**Title: Observing glacier elevation changes from spaceborne optical and radar sensors – an inter-comparison experiment using ASTER and TanDEM-X data**

Author(s): Livia Piermattei et al.  
MS No.: egusphere-2023-2309  
MS type: Research article

**Author’s response related to the comments received to the manuscript:**  
<https://doi.org/10.5194/egusphere-2023-2309>

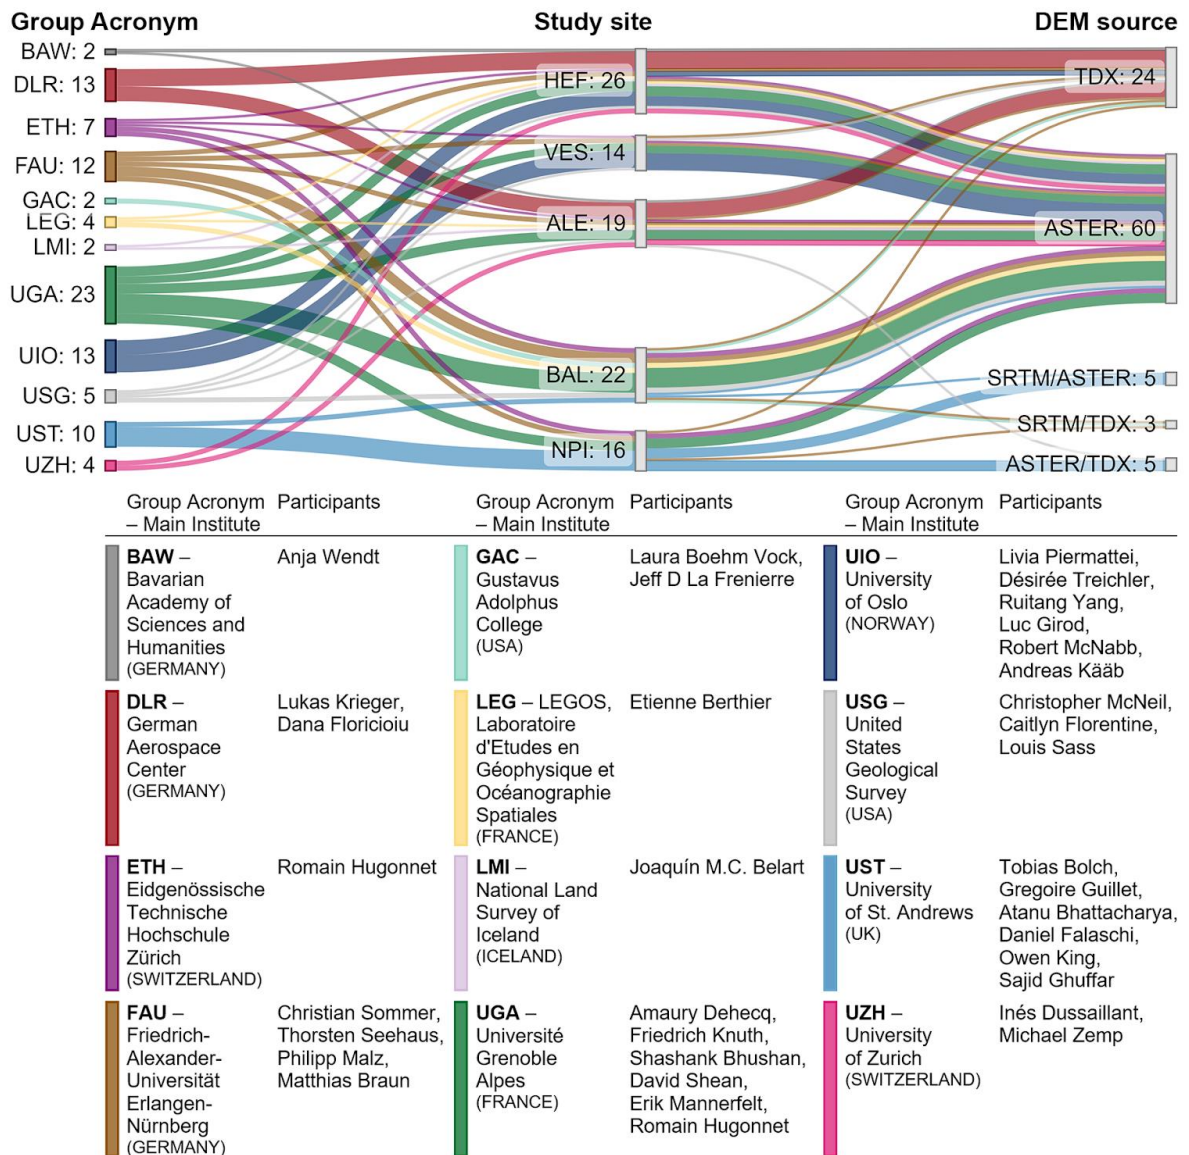
Figure 4 and section 3.x.x.x. – I wonder if there is a better way to show all 12 groups in the figure and in text. Readers have to refer to Supplement to know more about the groups and the members, which sometimes can be annoying. Can you provide a table in the manuscript referring to these members and groups. I know it will be cluttered but atleast useful not to check multiple documents at the same time. Think about it!

Response: We think that the Sankey diagram clearly shows how the study sites and DEM sources are connected to different groups. However, we agree that making the group members more visible is important. To address this, we included a table in Figure 4 that lists the names of the participants in each group with their main institution. Thank you for this suggestion.

“Figure 4: ... Sankey produced with Sankeymatic (SankeyMatic, 2023). At the bottom is the list of the participants in each group with their main institution.”
